TOWN OF GLASTONBURY
GL-2015-14
NEW TOWN FACILITIES AND MAINTENANCE BARN
ADDENDUM NO. 1
OCTOBER 31, 2014

BIDDERS ARE ADVISED THAT SITE PLAN SHEET NO. C-1 WAS REVISED:

PLAN
DEPICTING PROPOSED
FACILITIES MAINTENANCE BARN
located at
2109 MAIN STREET
GLASTONBURY, CONNECTICUT

SHEET NO.
C1

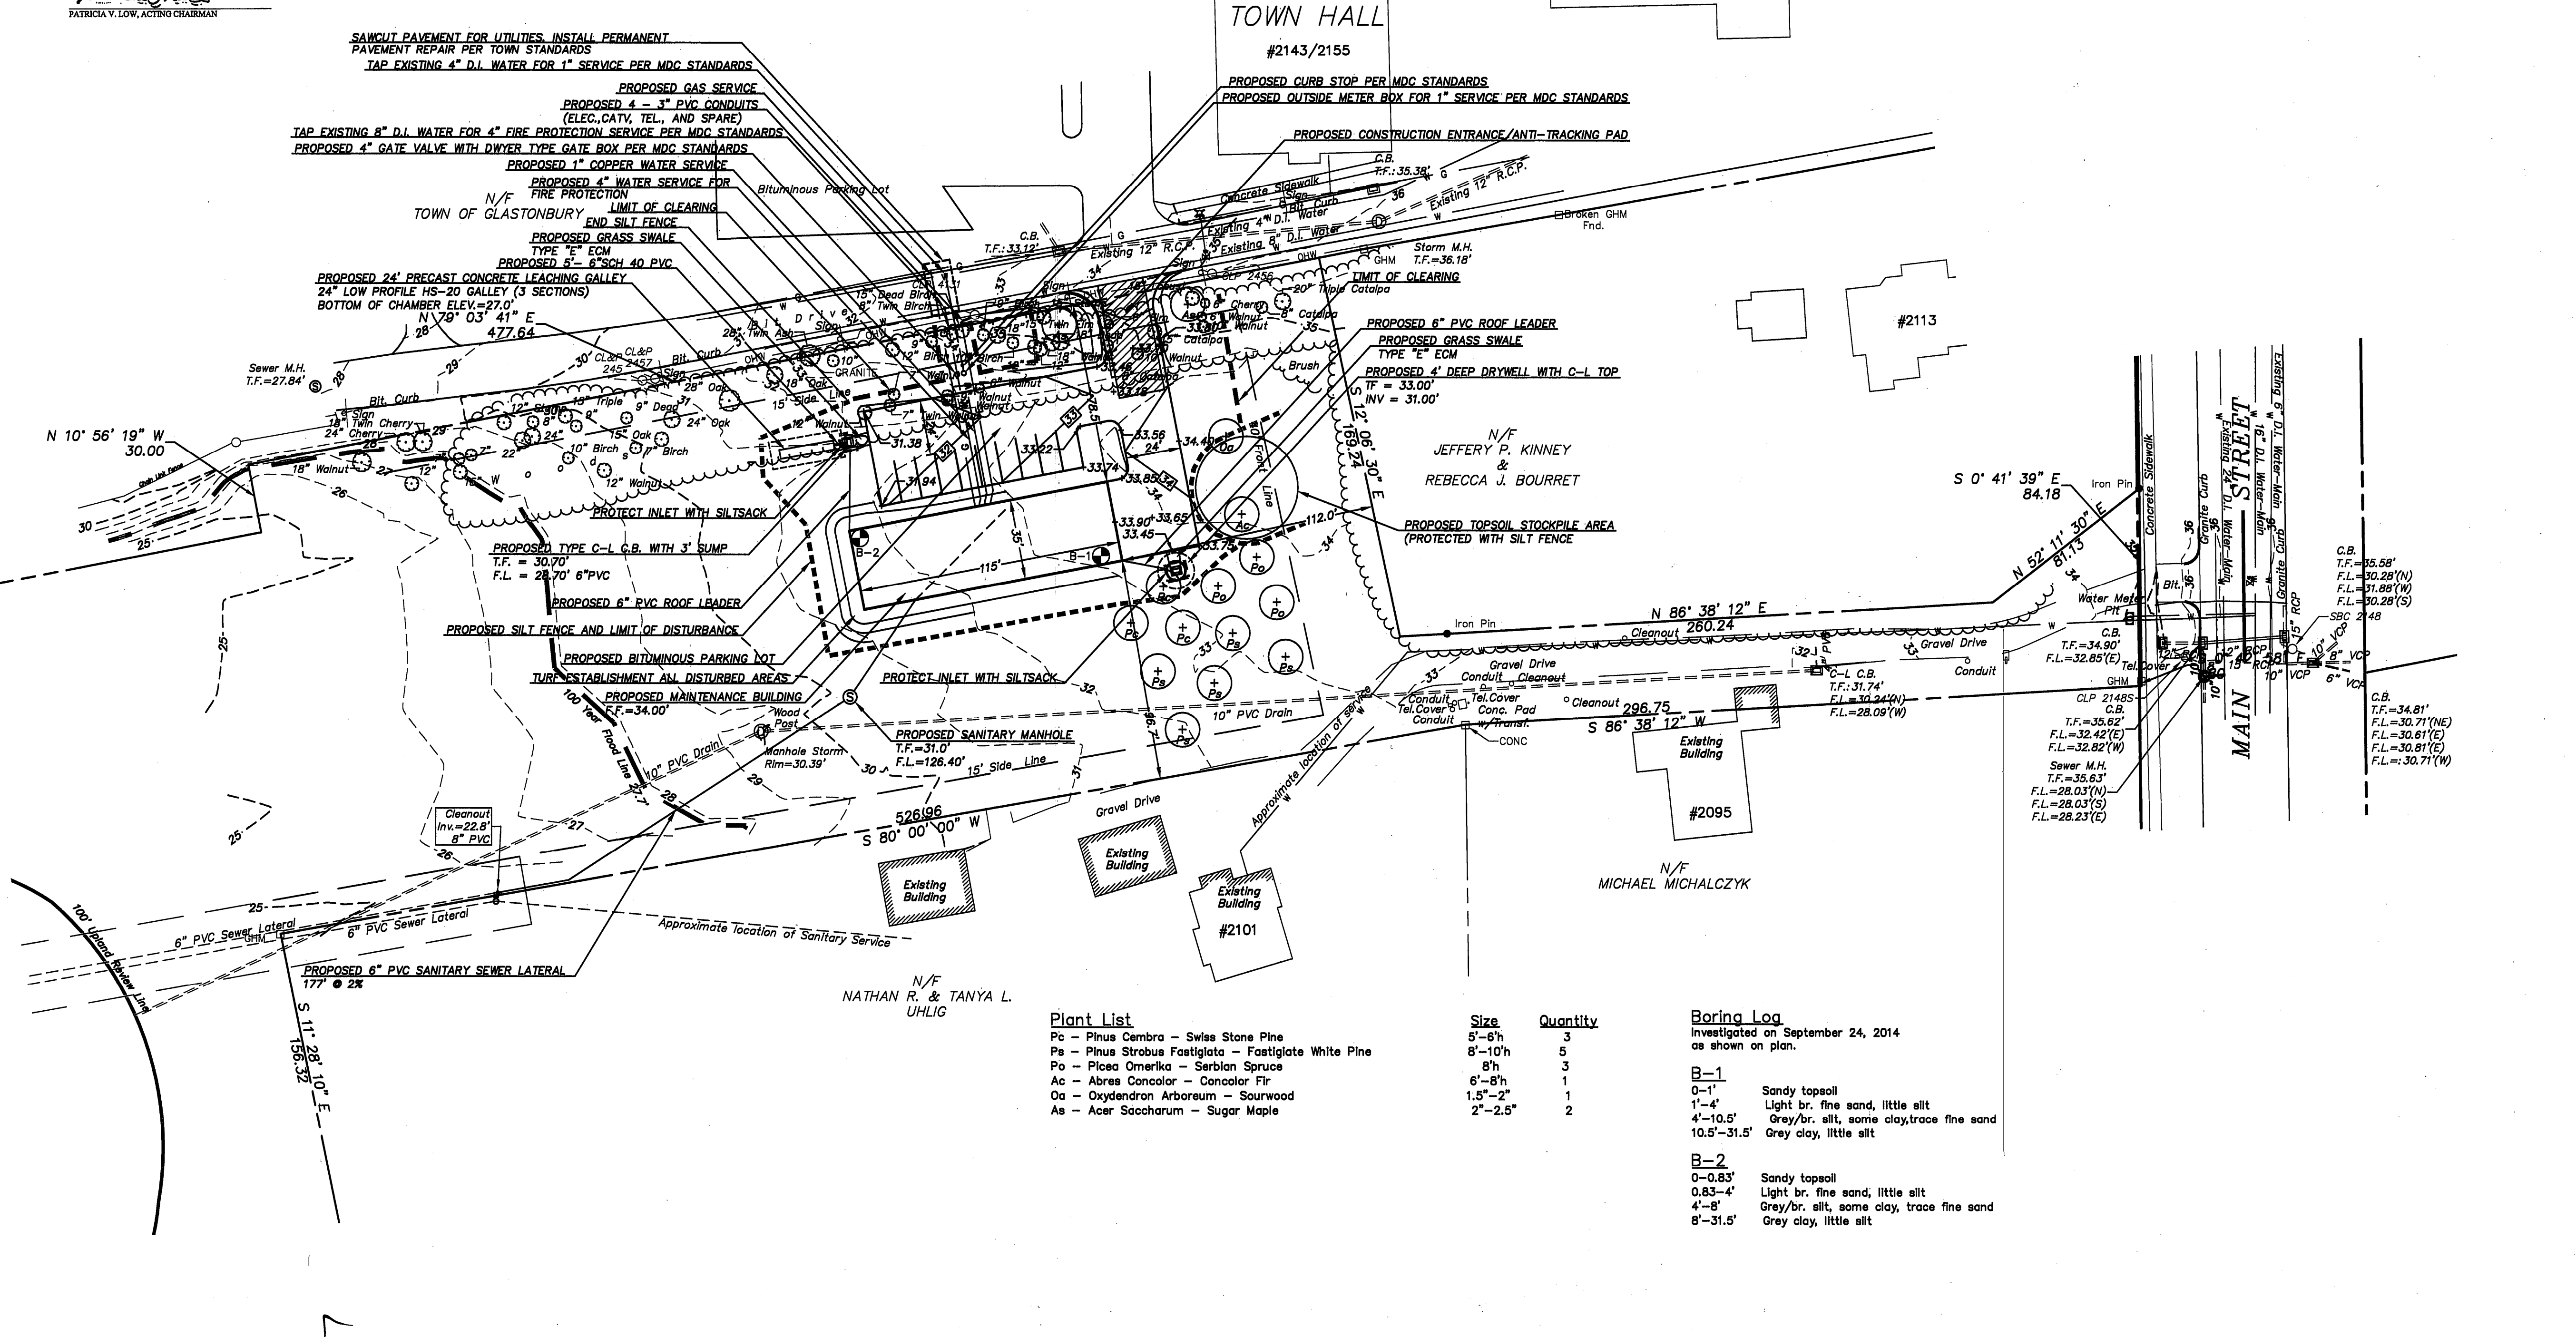
The attached plan has been REVISED to include the lines depicting the silt fence / clearing limit. These lines are not visible on the original plan that was included with the bid.
